APPLICATION NUMBER: RECON 25/1052

PROPOSAL: RESERVED MATTERS APPLICATION RELATING TO LAYOUT, SCALE, APPEARANCE, ACCESS AND LANDSCAPING FOR RESIDENTIAL DEVELOPMENT AT PHASE4E/4G

SITE: Glan Llyn Development Site Phase 4E/4G Queensway Llanwnern

Engineering plan extract showing very high number of bioretention strips with 1 in 3 slopes to all front and rear gardens

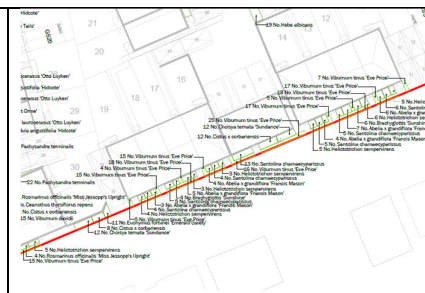
The engineering plans show a very high number of small bioretention areas to **all front gardens** which are not reflected in the Detailed Planting Proposals. The species proposed may not cope with the conditions. This needs clarification.

The engineering plans show a very high number of small bioretention areas to **all rear gardens** which are also not reflected in the Detailed Planting Proposals. The areas are not shown as planted so presumably these will be grassed. This needs clarification.

As bioretention proposals will have slopes at 1 in 3 max, this will remove significant useable space from already small rear gardens – refer to extract below left.

Extract from detailed planting sheet 1

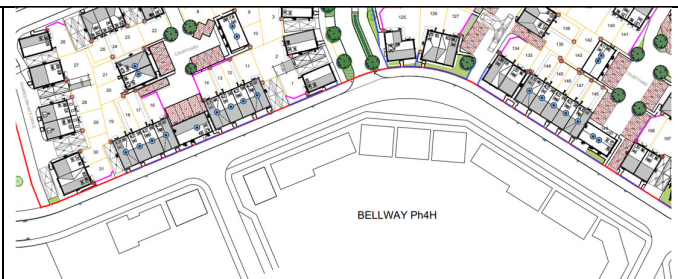
The extract below left previously showed a grass strip which offered potential for tree planting but this has now been removed. The context of the site to the west is important to understand as the proposal offers a wide hard surface of path plus shared drive directly onto housing with no structural planting.

The southern boundary – extract above right - offers no street tree or structural hedge planting and the layout provides no room. As house elevations are set back only around 2m from the back of footpath and a similar design layout is shown on Bellway Phase 4H this will create a poor designed residential corridor.
